Daimler Buses Recall Bulletin

Orion V/VII Models

NHTSA 08V-480/TC 08-354

1.0 CABLE ROUTING RECALL NOTICE

FIGURE 1-1 IMPROPERLY ROUTED CABLES IN CONTACT WITH FUEL LINES

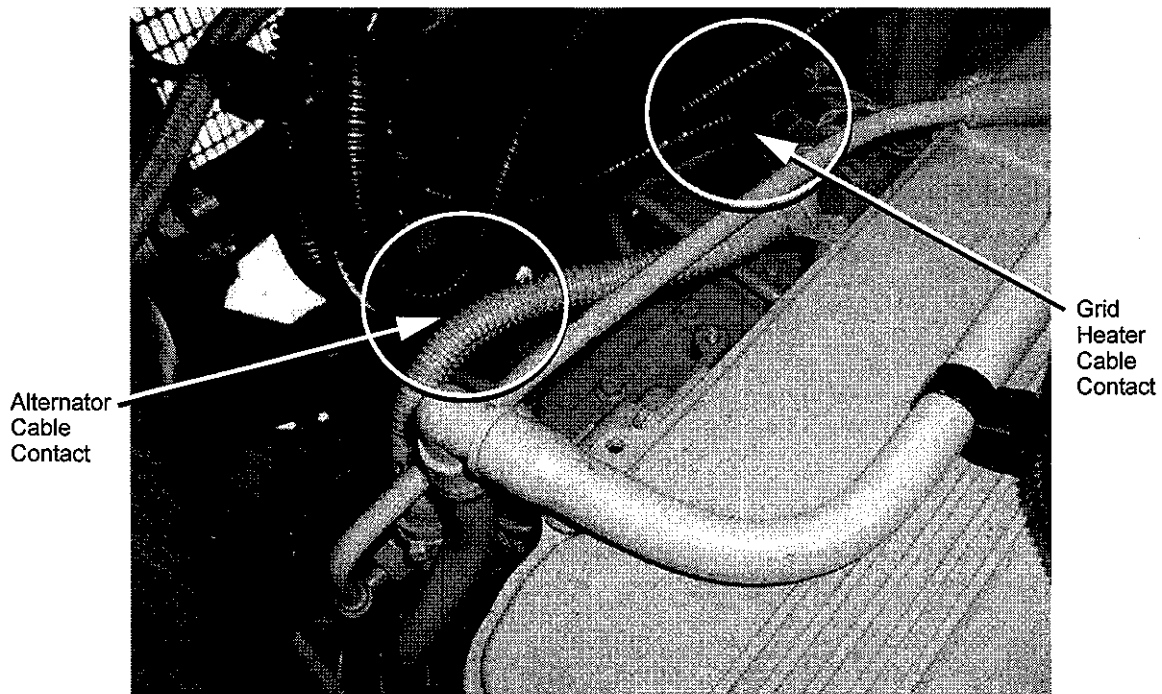
3. Inspect the alternator cable and grid heater cable for proper routing in the rear engine compartment to avoid the possibility of rubbing/chaffing against the #3 and #4 fuel injector lines. (See Figure 1-1.)
 - a. If the cables come in contact with the fuel injector lines as indicated in Figure 1-1 but no damage is found, reroute the cables following the procedure outlined in "Rerouting Improperly Routed Cables" on page 5.
 - b. If the cable loom or insulation is damaged on either cable, replace the cable(s) as indicated in "Alternator Cable Replacement" on page 6 or "Grid Heater Cable Replacement" on page 6.

If the alternator cable and grid heater cable are making contact with the #3 and #4 fuel injector lines as indicated in **Figure 1-1** but no damage is found:

1. Loosen the p-clamp or clamps securing the alternator and grid heater cables in the rear engine compartment.
2. Lift the cables clear of the injector line(s) and secure with a Dual Clamp Tie (**ORION P/N 051048002**) as indicated in **Figure 1-3**.
3. Re-tighten any p-clamps loosened in **step 1**.
4. Close the interior access panel located under the rear center seat section inside the bus.
5. Return the battery isolator switch to the ON position.

FIGURE 1-2 CHAFFING DAMAGE TO FUEL INJECTOR LINE

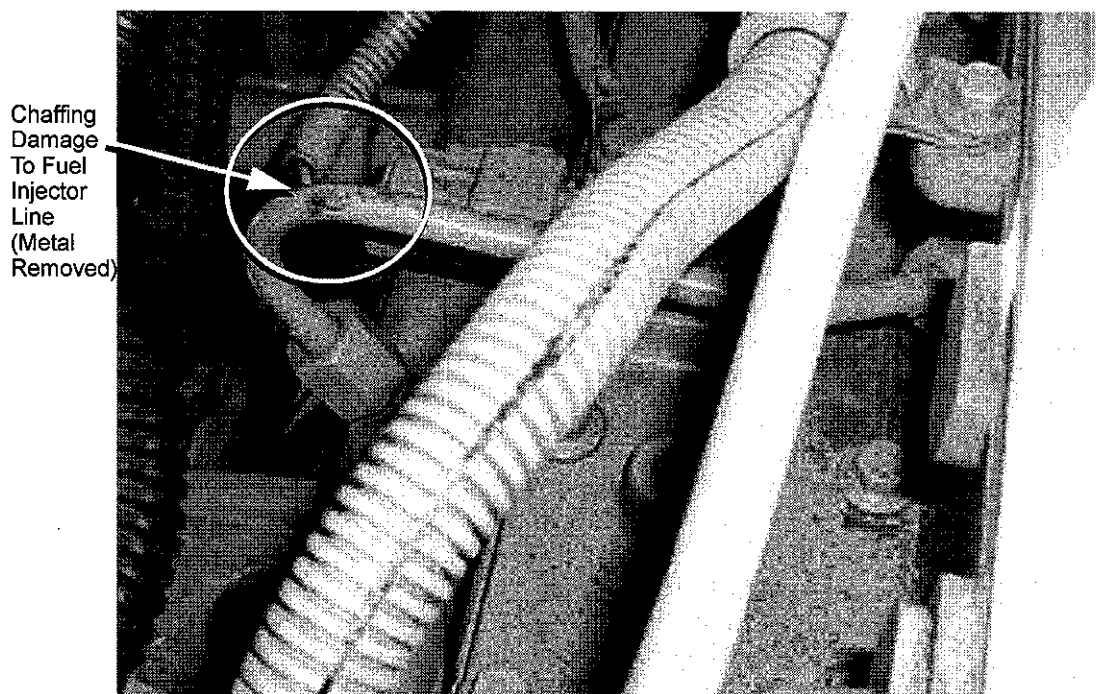
4. Inspect the #3 and #4 fuel injector lines for chaffing damage as shown in Figure 1-2. If any metal has been removed, replace the fuel injector line as indicated in "Fuel Injector Line Replacement" on page 6.

To replace the #3 or #4 fuel injector lines, follow the procedures outlined in the Cummins maintenance manual provided with your vehicle.
